Responses to Comments on DG-1247

Draft regulatory guide DG-1247, and two technical references to it, NUREG/CR-7004 and NUREG/CR-7005, were issued for public comment. Two public comments were received. A third comment generated internal to the NRC was also considered. This document contains the staff's understanding of the three comments and the staff's responses to them.

Figure 1. Comparison of modeled and observed peak gust wind speeds for Hurricane Charley showing the inland extent of strong winds. Note the high winds in Orlando (KMCO) which is 200 km inland from the landfall location. Dashed lines shown in the scatter plot indicate $\pm 10\%$.

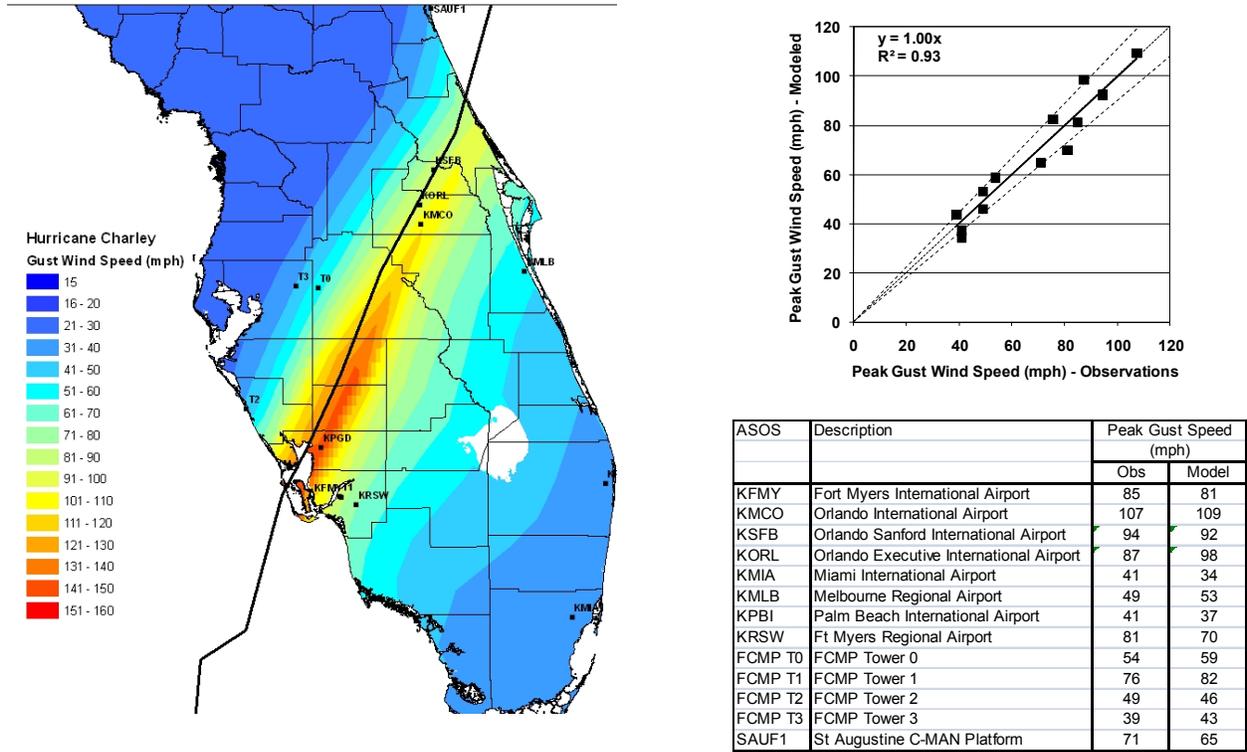
Comment within the introductory paragraph. “...the methodology has resulted in a significant departure from historical wind speed data and has significantly extended these wind speeds inland.”

Response: *The wind field model has been validated using historical wind speed data as described in numerous papers and reports (e.g. Vickery et al., 2000, Vickery et al., 2009a). Those comparisons indicate that the model performs well both at the coast and inland. Many of these comparisons were presented in the Technical Basis document NUREG/CR-7005, as well as in Vickery et al. (2009a). The inland wind speeds are based upon the well validated wind field model that properly treats the sea-land transition and the growth of the hurricane boundary layer as the storm progresses inland. This wind model is coupled with a filling model (increase in central pressure as the storm moves inland) which is described in detail in Vickery (2005). The filling model weakens hurricanes fastest in the case of small, intense, fast moving hurricanes, such as Hurricane Charley. Figures 1 and 2 present model gust wind swaths for the 2004 Hurricanes Charley and Jeanne in Florida. Notice the inland extension of the strong winds associated with both hurricanes. The marine winds (which are 10% to 15% higher than the open terrain winds) are not shown in these Figures. Also note the good agreement between modeled and observed winds at both near coast and inland locations.*

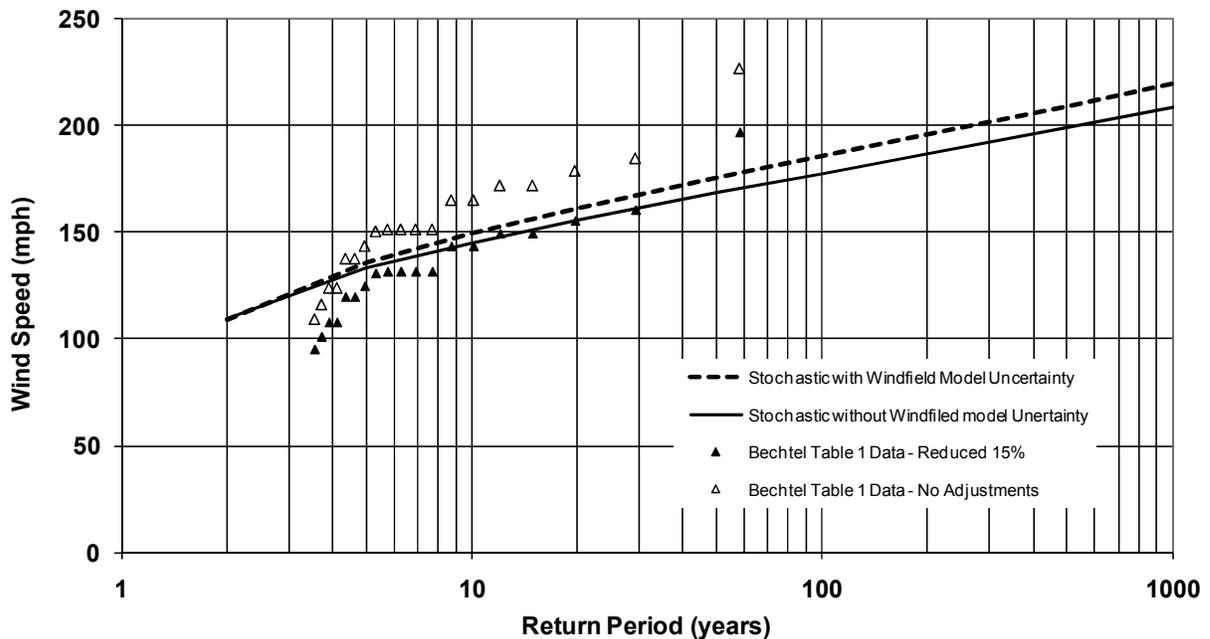
Comment 1. In the five coastal regions the design-basis gust winds provided in DG-1247 are often more than 30% higher than the HURDAT wind speed values obtained from historically significant hurricanes. Table 1 summarizes the significant storms that were investigated for this study. This set was selected based on damage caused at landfall and damage during the inland progress of the storm. Storm tracks are provided in attached Figures 1a – 1m, and the proposed contours from DG-1247 are superimposed on these figures. Consideration should be given to calibration of the 10^{-7} per year gusts to historical values for land-falling wind speeds.

i) Regional Analysis A more reasonable comparison using the data given in Bechtel's Table 1 is to show ARA's predicted hurricane hazard curve along with an empirically based hazard curve developed using the Bechtel data (from their Table 1) that applies to a large region, the size of the coastal United States. This comparison is shown in Figure 3. The hazard curve

The empirical hazard curve obtained from the Bechtel data was developed using a similar approach, where we rank ordered the gust wind speeds given in Table 1. (If two wind speeds appear in the gust wind speed column in Table 1, we used the values labeled H). A CDF was then computed from the rank ordered data and used in a Poisson based risk model (with the annual occurrence rate defined as the total number of wind speeds (19) divided by the total number of years (57)), to develop a wind speed hazard curve. Two empirically based curves were developed, one for the case where the wind speeds given in Table 1 were used without modification, and the other developed assuming the wind speeds given in Table 1 are marine values, and so we convert them to land based values by reducing the gusts by 15%. This 15% value is suggested by Bechtel, but it overstates the true reduction in the peak gust wind speed as the wind moves from a marine terrain to an open terrain, which varies between 10% and 15%, but is closer to the 10% value.

The comparison in of the Bechtel winds and the model winds in a rationale manner as seen in Figure 1 indicates that the return periods associated with the model winds agree with, or are higher (indicating that the model yields approximately equal or lower winds for the same return period) than those derived from the wind data provided by Bechtel.

Figure 6. Comparison of modeled and observed peak gust wind speeds for Hurricane Hugo showing the inland extent of strong winds. Note the high winds in Charlotte, NC (KCLT) which is located almost 300 km inland from the landfall location. Dashed lines shown in the scatter plot indicate $\pm 10\%$.

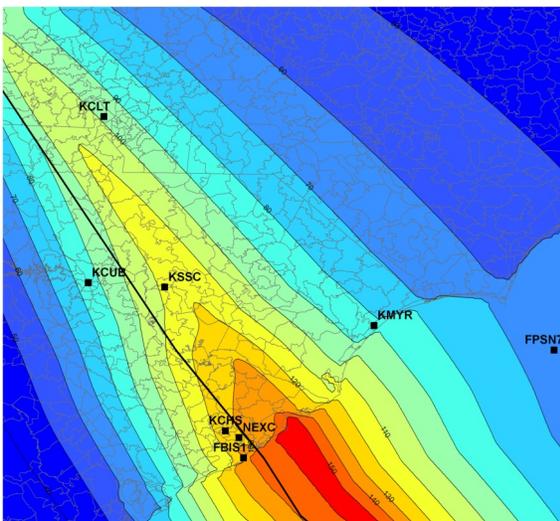
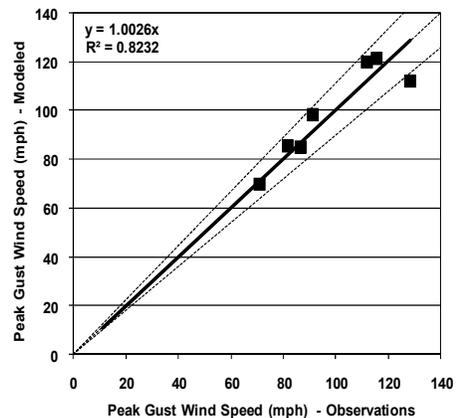
“Simplified HURDAT data were examined for Category 4 and 5 storms for storm motion. Storms with more rapid forward movement tend to have direction changes to the east, accelerating forward motion immediately preceding rapid decreases in intensity. These are indicative of hurricane interaction with mid-latitude troughs and weakening. The rapid decrease in intensity of these observed storms suggests that while some storms can be observed to have this high forward speed, this subset would be weakening prior to landfall, and the subsequent loss of inflow after landfall would decrease the overall intensity faster than the DG-1247 model predicts. In general, it has been concluded that hurricane wind speeds in flat terrain decrease by about 15% in the first 15 km from the coast (Reference 14).”

Furthermore, the model does include a reduction in peak gust wind speed moving from sea to land. This reduction is in the range of 10% to 15%, varying primarily with storm size, and is evident in Figure 6 (discussed below).
